Re: Turkey Point Units 3 and 4  
Docket Nos. 50-250 and 50-251  
Response to NRC Reactor Systems Branch Request for Additional Information  
Regarding Extended Power Uprate License Amendment Request No. 205  
and Thermal Conductivity Degradation

RESPONSE TO NRC SRXB RAI REGARDING EPU LAR NO. 205  
AND THERMAL CONDUCTIVITY DEGRADATION

## Response to Request for Additional Information

**Figure 5-1**  
**Rod Ejection – Beginning of Cycle / Hot Zero Power Case**

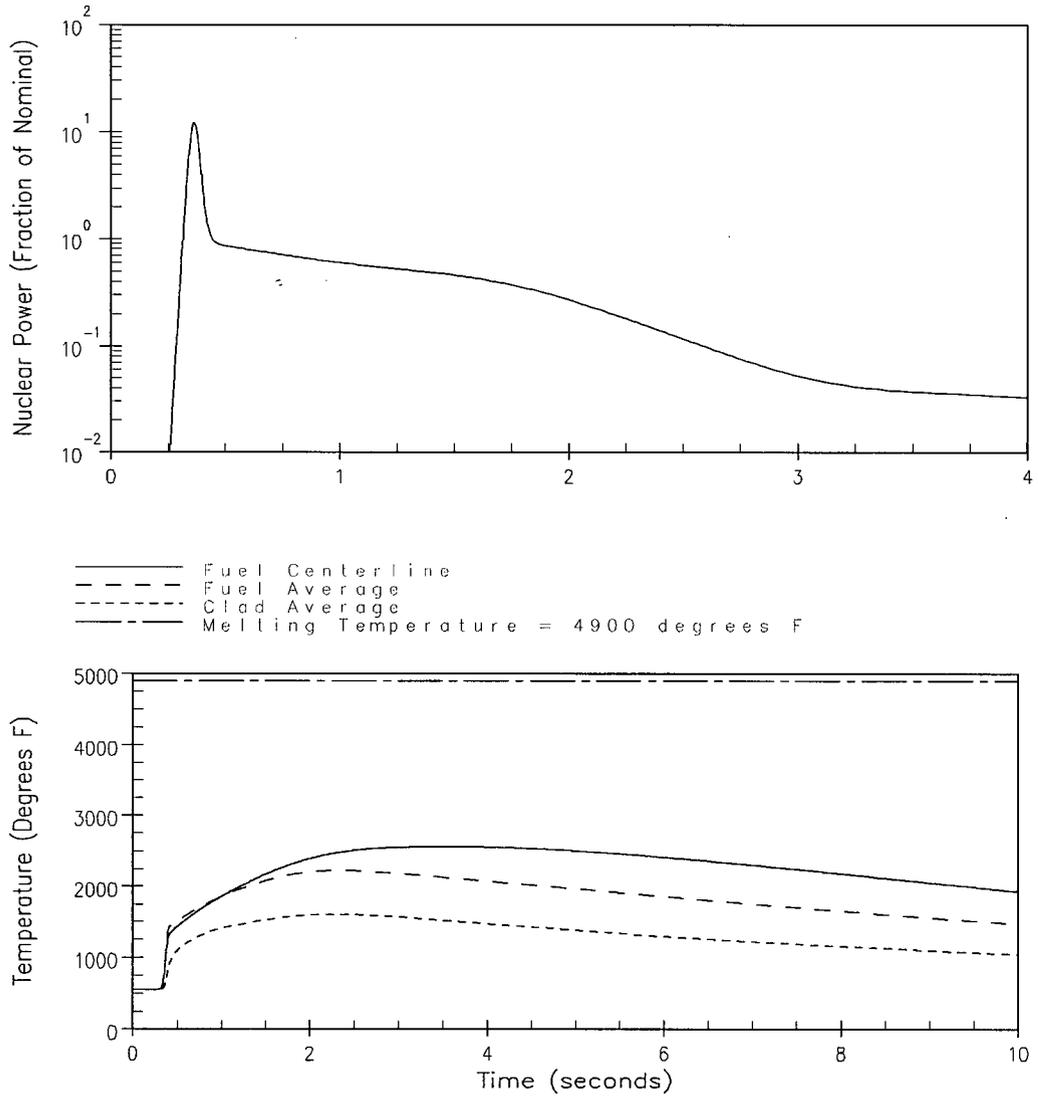
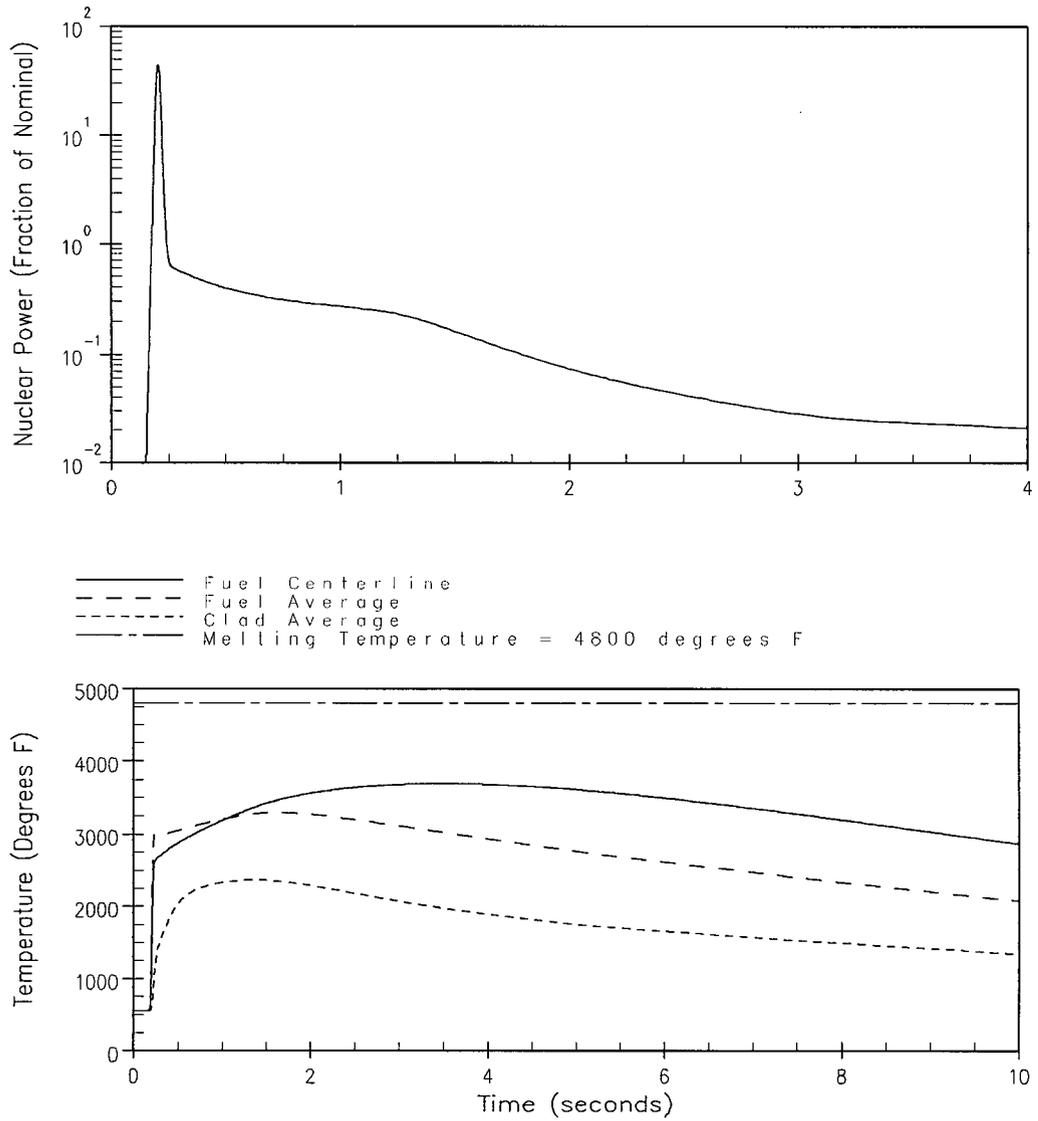
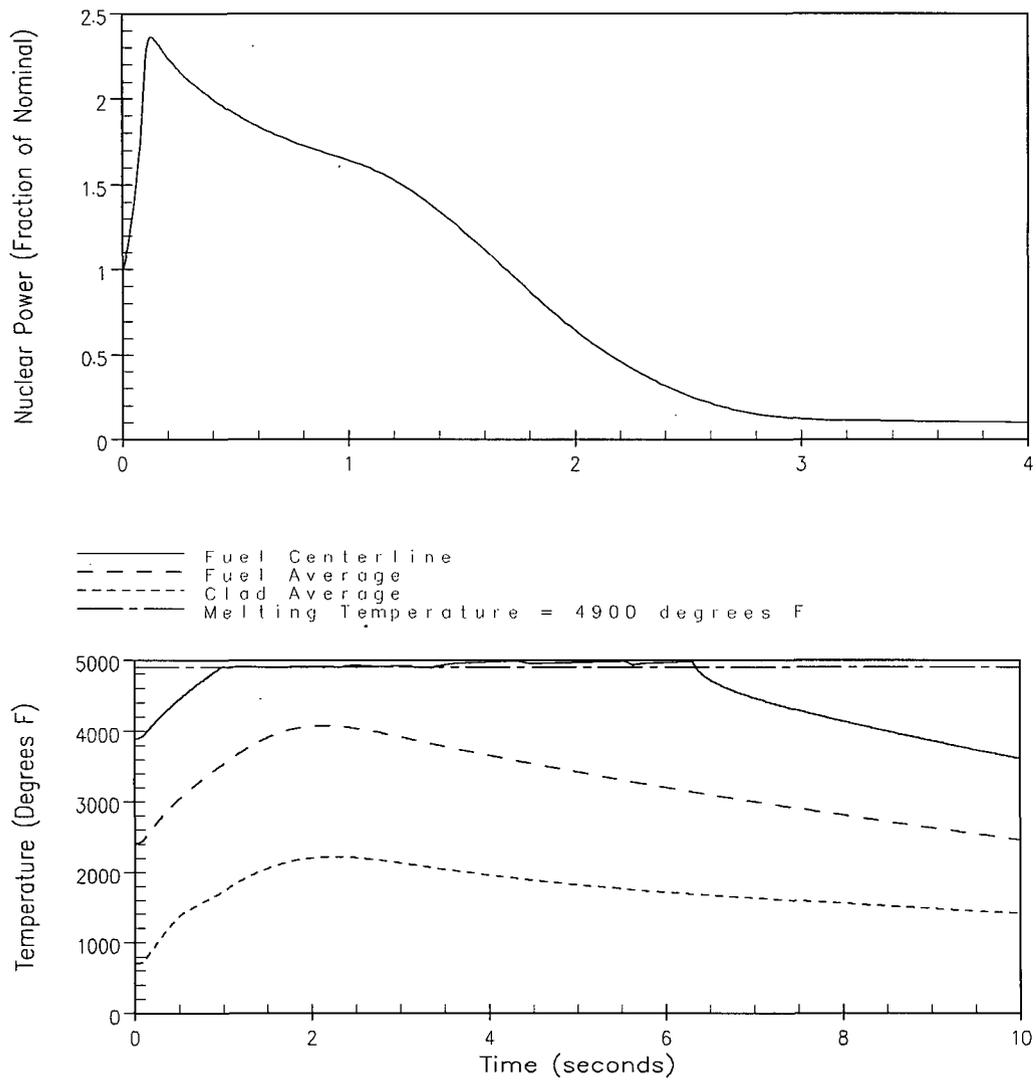
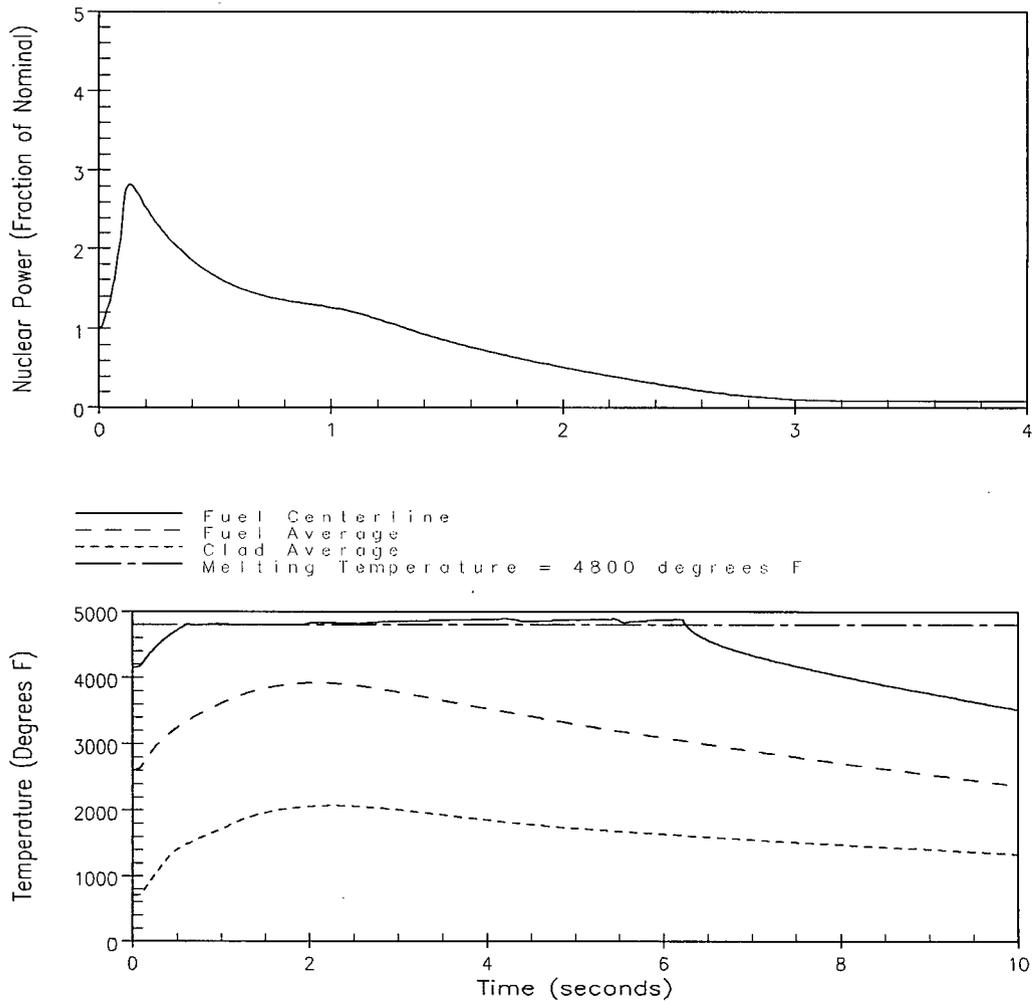
Two portions of the FACTRAN input files have been revised to address the impact of TCD. First, the input maximum fuel temperatures used to calibrate initial conditions in the fuel pellet for the hot full power (HFP) RCCA ejection cases have been updated to reflect the fuel temperatures with TCD. Secondly, the input to FACTRAN has been modified for all the RCCA ejection cases analyzed to model fuel conductivity that reflects the impact of TCD. The fuel conductivity inputs used are burnup dependent. Therefore, the FACTRAN inputs used for BOC and end of cycle (EOC) fuel conductivity are different. It is important to note that the subject FACTRAN input changes are completely consistent with the existing methodology for analyzing the RCCA ejection accident.

Compared to the results reported in the EPU Licensing Report, the results in Tables 5-3 and 5-4 show that inclusion of TCD had very little impact on the cases initiated from HZP conditions. For the HZP cases, the fuel temperatures and the maximum fuel enthalpy did increase due to TCD but these increases were relatively small and no safety analysis limits were approached. For the HFP cases, inclusion of TCD did increase the maximum fuel stored energy and substantially increased the predicted fuel melting. However, all safety analysis limits continued to be met for the rod ejection event with TCD.

**Figure 5-6**  
**PTN HOTSPOT Clad Temperature Transient at the Limiting Elevation for the Limiting PCT and MLO Case**

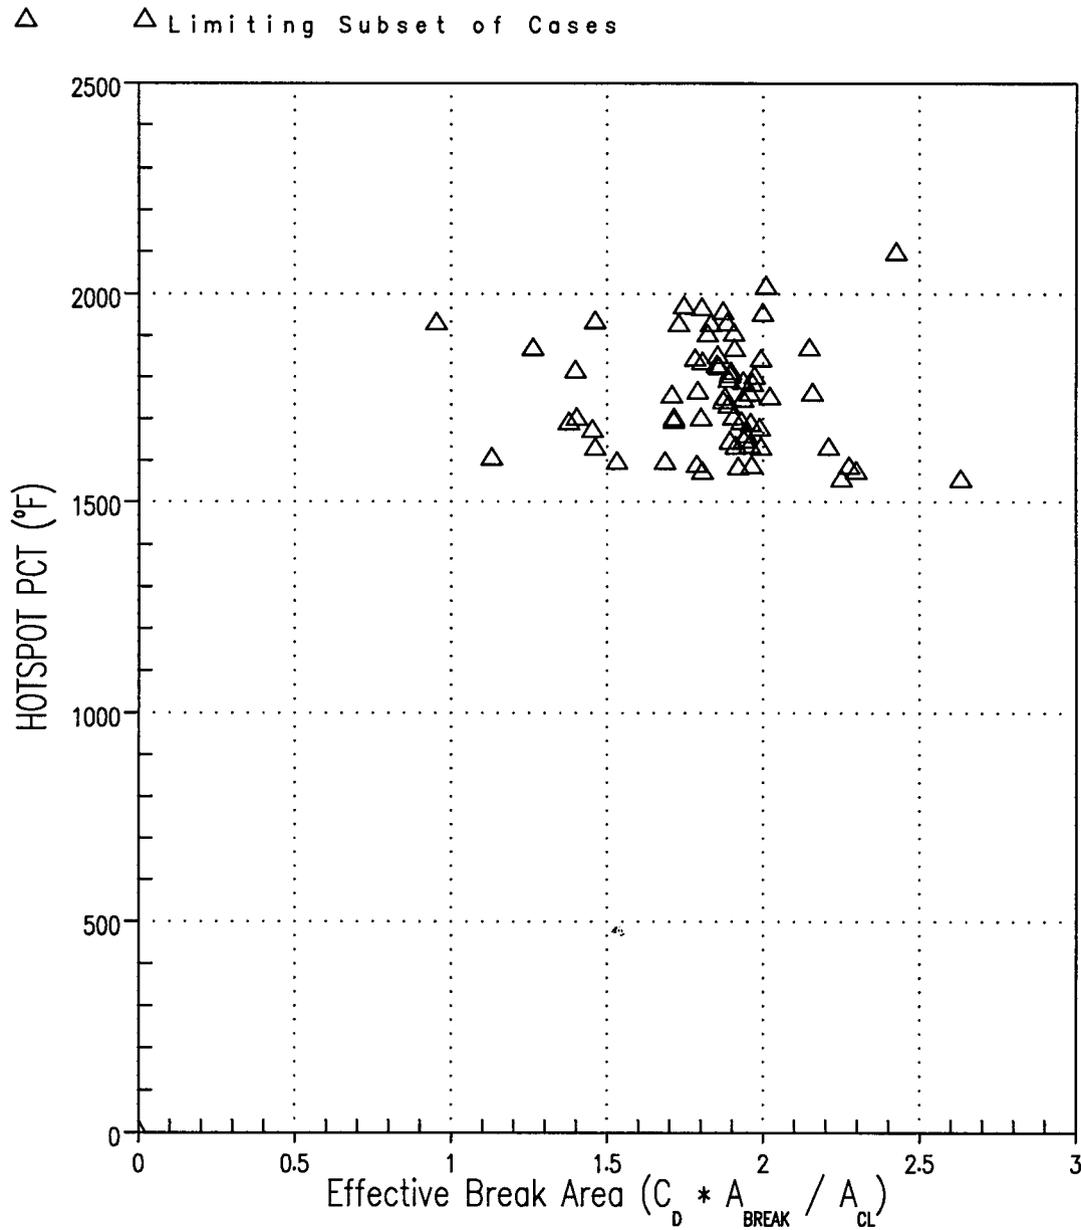
Figures 5-6 and 5-7 are presented to show the limiting cladding transient for each 10 CFR 50.46 criterion evaluated in the updated BELOCA analysis considering the effects of TCD. Figure 5-6 shows the HOTSPOOT predicted clad temperature transient at the PCT and MLO limiting elevation for the limiting PCT and MLO case. Figure 5-7 shows the WCOBRA/TRAC predicted peak cladding temperature for the CWO limiting transient.

**Figure 5-21**  
**PTN HOTSPOT PCT vs. Hot Rod Burnup**

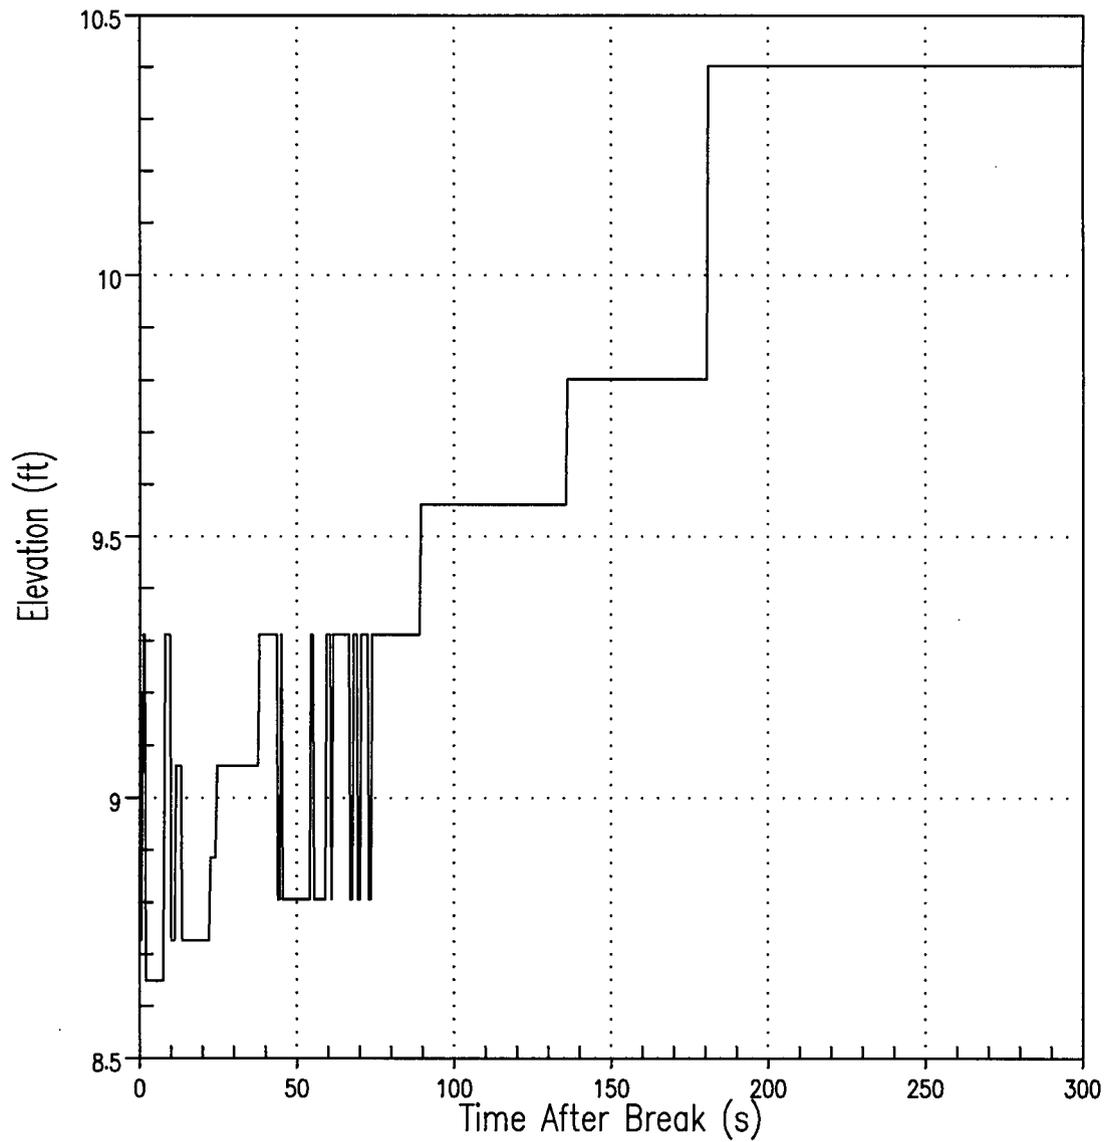
It is noted that the most severe analyzed case in the ASTRUM analysis (LR Section 2.8.5.6.3.2 (Reference 1)) had an assumed hot rod burnup of 1,552 MWD/MTU (per response to RAI SRXB-1.3.33). When considering the effects of TCD, the most severe case had an assumed hot rod burnup of 26,827 MWD/MTU. The change in hot rod burnup of the most severe case analyzed is expected since fuel average temperature increases as a function of burnup when explicitly modeling TCD. The increased fuel

average temperature leads to an increase in blowdown heatup, and this PCT increase is carried through refill and to the time of PCT. Figure 5-21 shows the PCT as a function of hot rod burnup in the limiting subset of runs performed as part of the updated BELOCA analysis considering the effects of TCD.
